## **Addendum No. 1**

City of Coquitlam

**RFP No. 22-010**

### **Mundy Park Trail Realignment**

### Basic Series 1

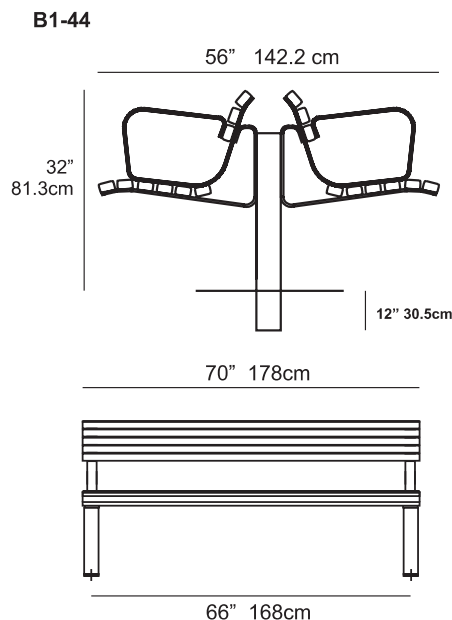
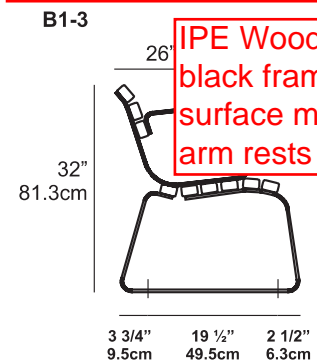
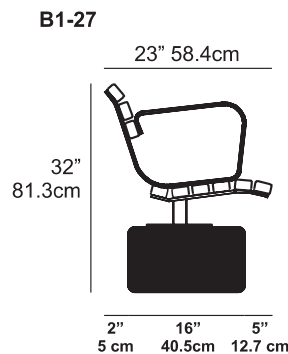
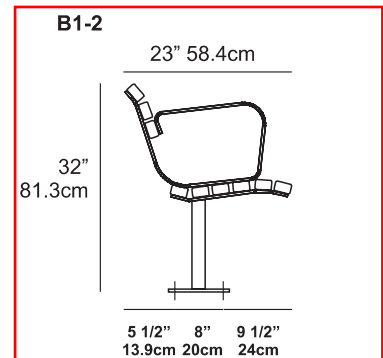
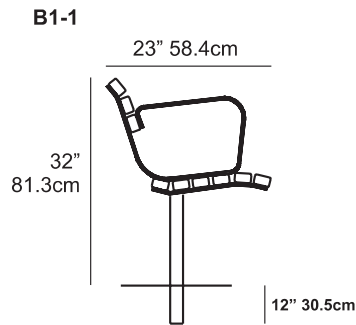
- Q7) Are you able to provide a spec for the bicycle baffles?
- A7) **Bike Baffle specifications included as Attachment 1 as part of this Addendum No. 1. Shop drawings to be submitted to City for review and approval.**
- Q8) The Frances Andrew bench shown on the drawings lists model B1-1 as surface mounted. B1-1 is actually an in ground model. B1-2 is surface mounted. Are you able to confirm the model required?

- A8) **B1-2 bench specifications included as part of addendum. Shop drawings to be submitted to City for review and approval.**
- Q9) Are you able to provide a spec for the woven geotextile required on the pathways?
- A9) **Specifications for woven geotextile for pathways is Nilex 4553**

Bollard Post, Model R-7901

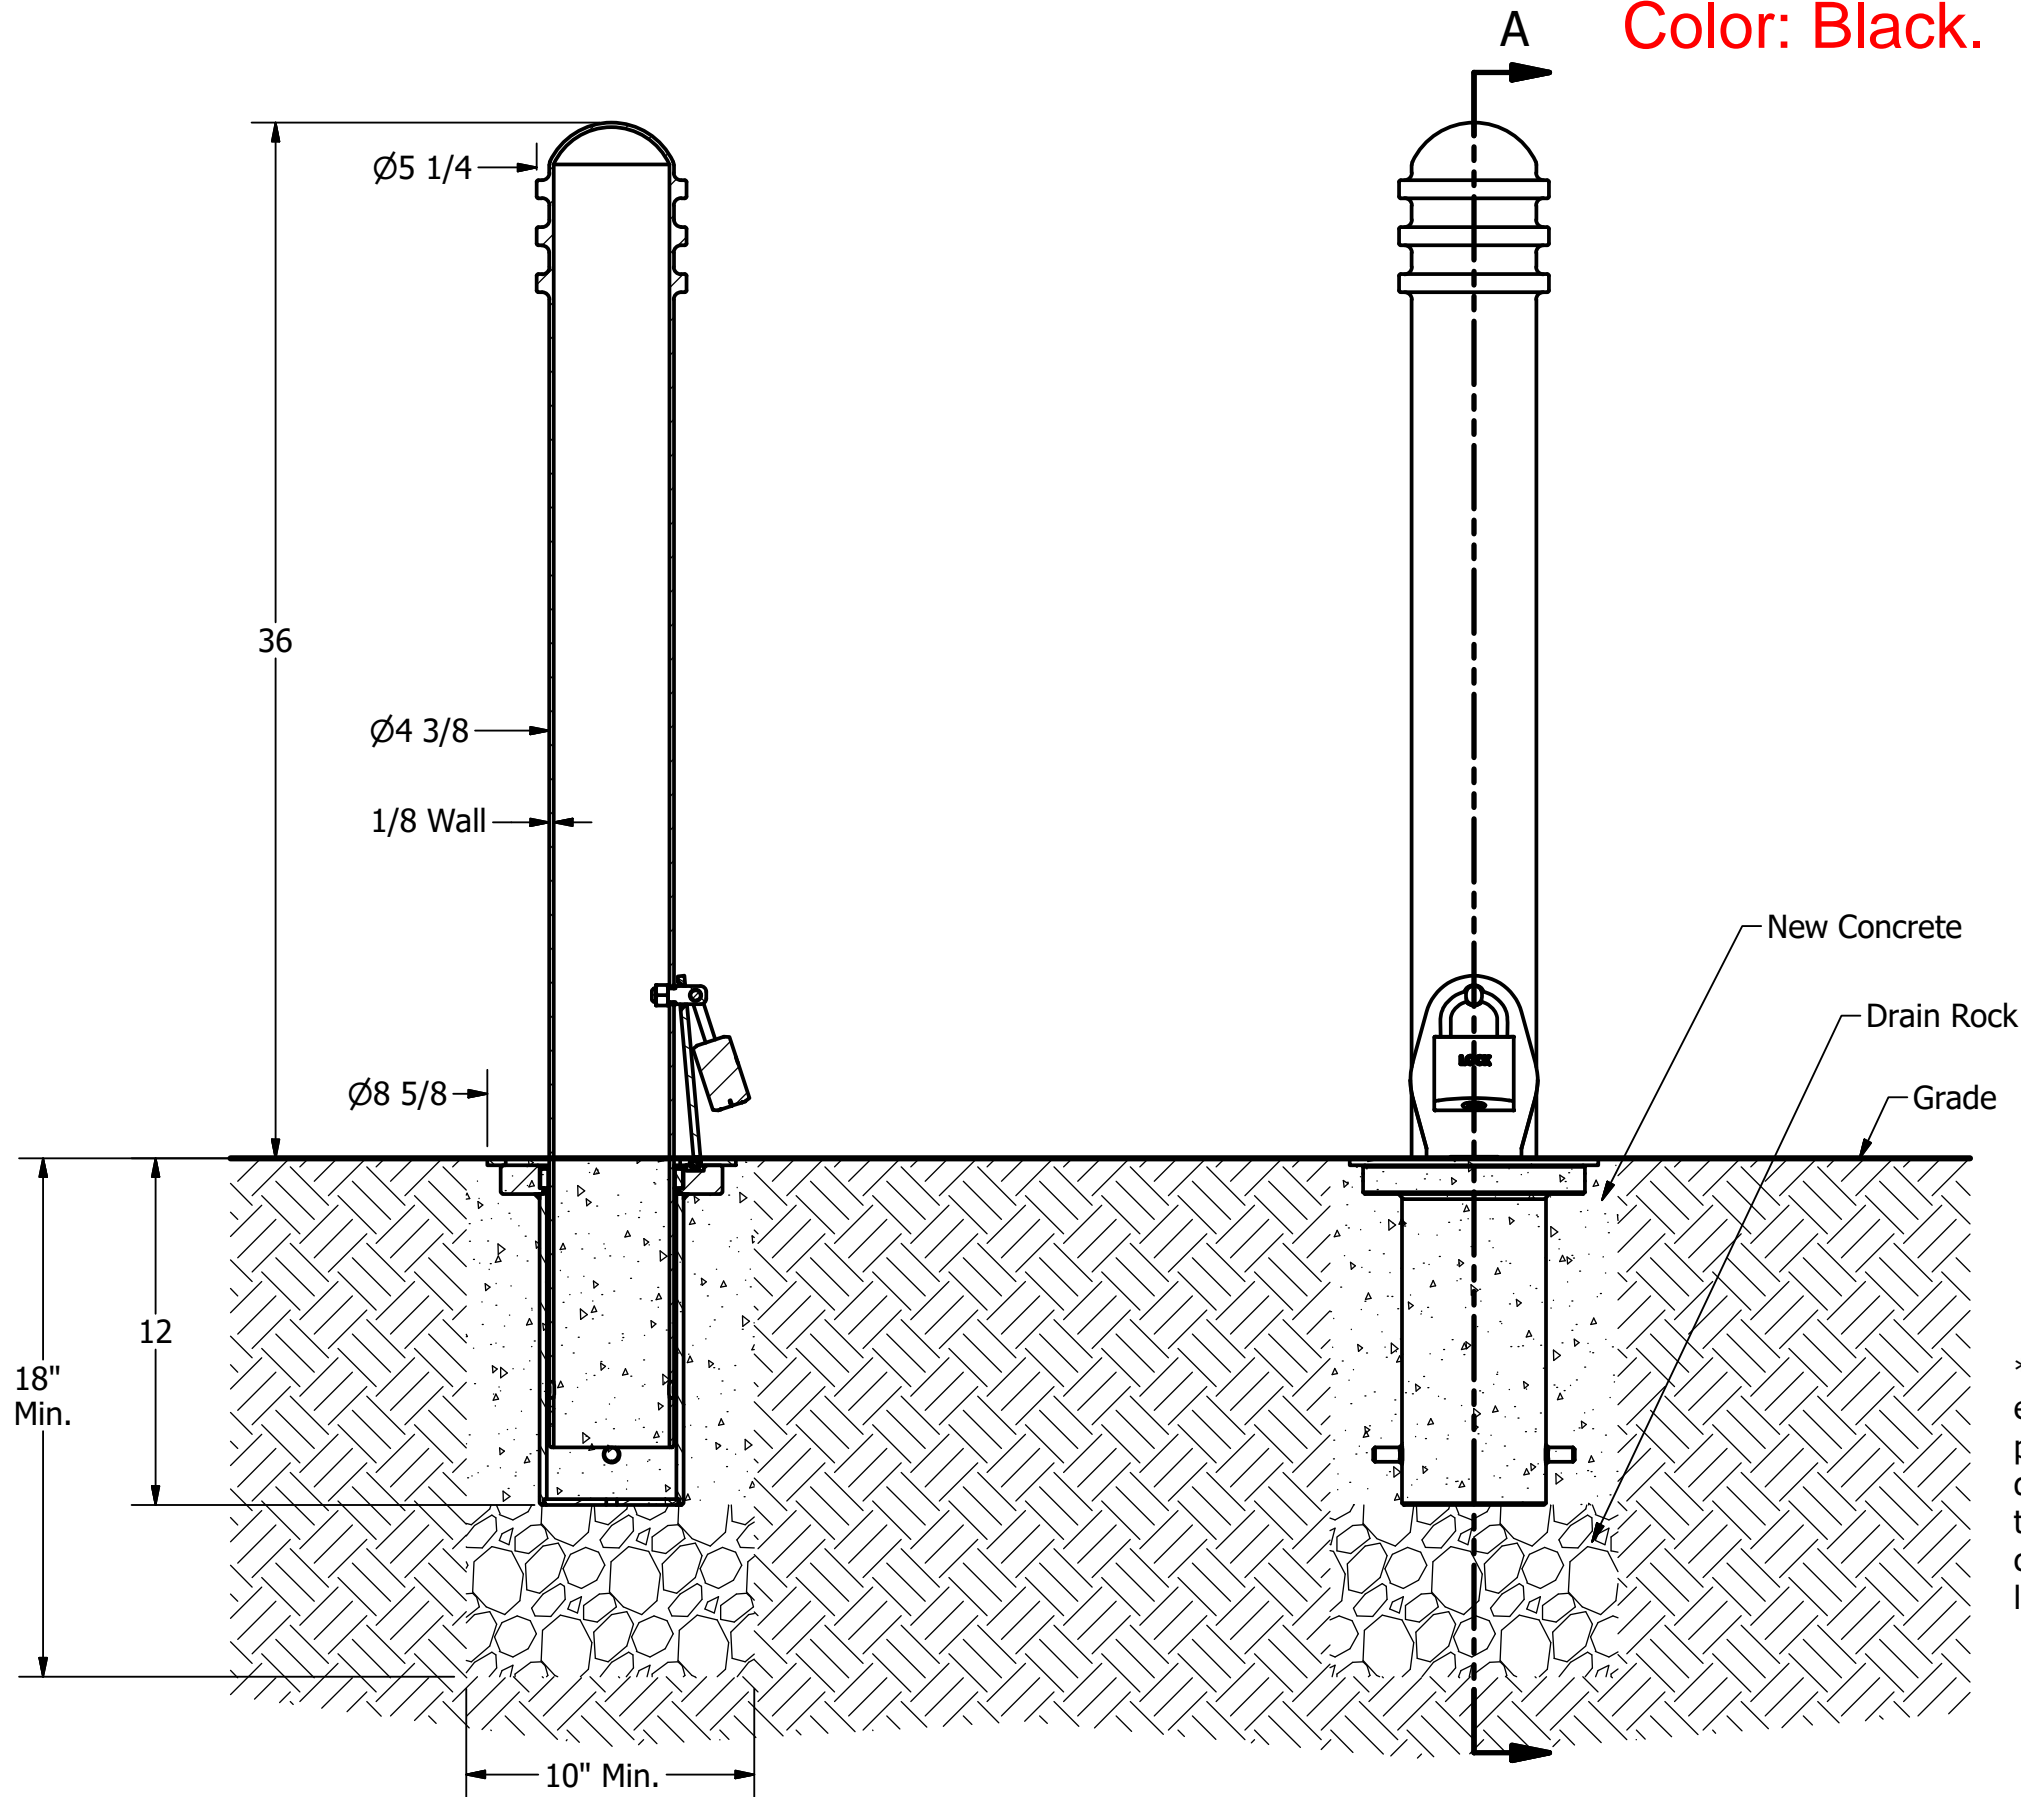
- Q6) Are you able to provide a spec for the removable bollard?
- A6) Removable bollard specifications included as Attachment 1 as part of this Addendum No. 1. Shop drawings to be submitted to City for review and approval.**
